From: PUBCOMMENT-OCC
Sent: Wednesday, February 11, 2015 9:34 AM
To: PUBCOMMENT-OCC2
Subject: FW: Public comment on Permit Number WQ0010232002
Attachments: Bechtol Request for Contested Case Hearing.pdf

REGULATED ENTY NAME GRUENE ROAD PLANT

PERMIT NUMBER: WQ0010232002

Re: Hearing Request On Draft Permit No. WQ0010232002, Proposed for Issuance to New Braunfels Utilities

ATTACHMENT 2 AFFECTED LANDOWNER MAP

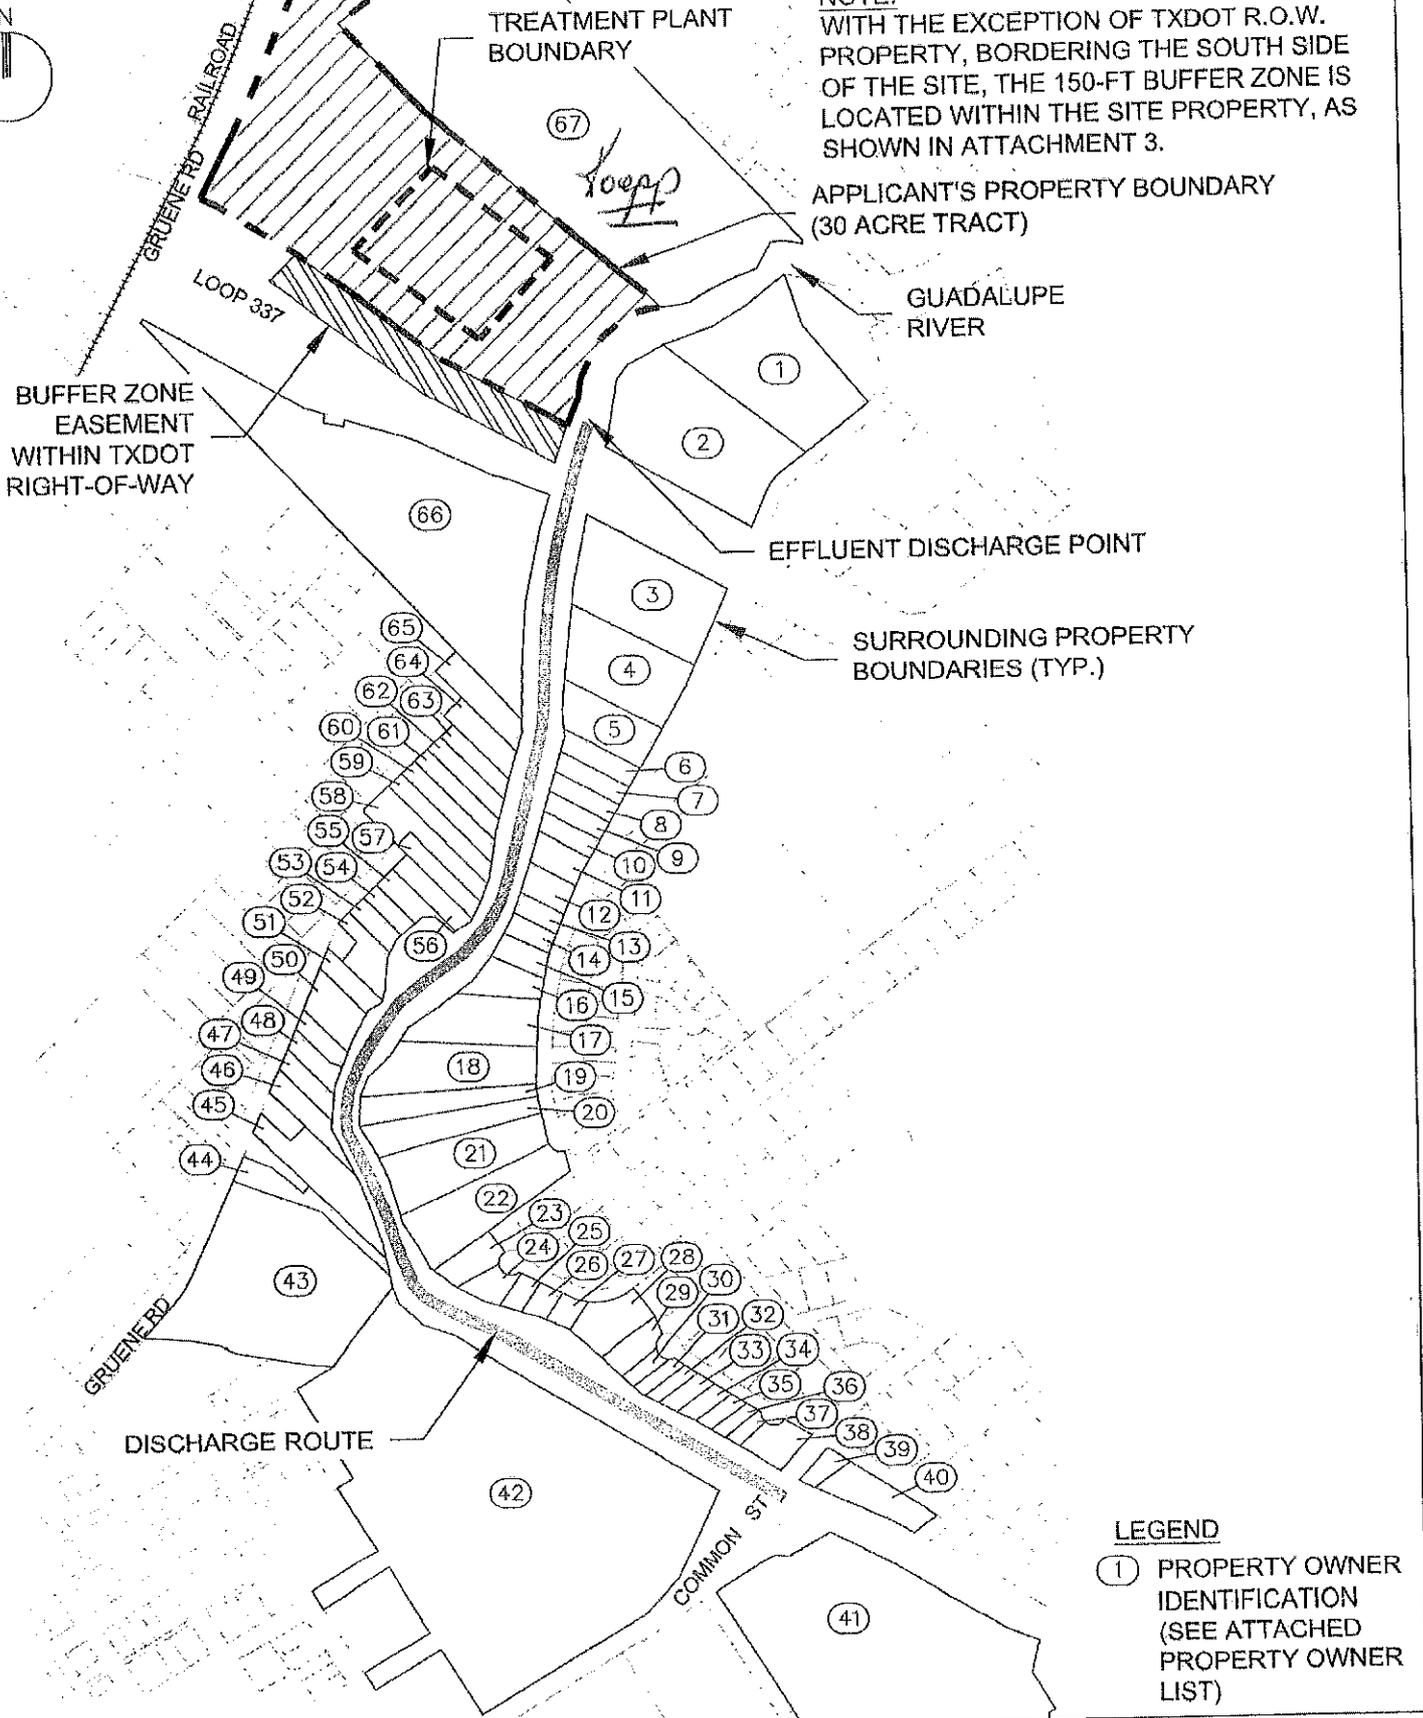
I, Skylar Koepp, own riverfront property located directly across from the purposed treatment plant in New Braunfels. My daytime telephone number is 830-608-4658. I am the owner of Property No. _67_ as designated in the applicant's Affected Landowners' Map accompanying the application. My riverfront property is located next to the proposed discharge point of the proposed relocated wastewater facility.
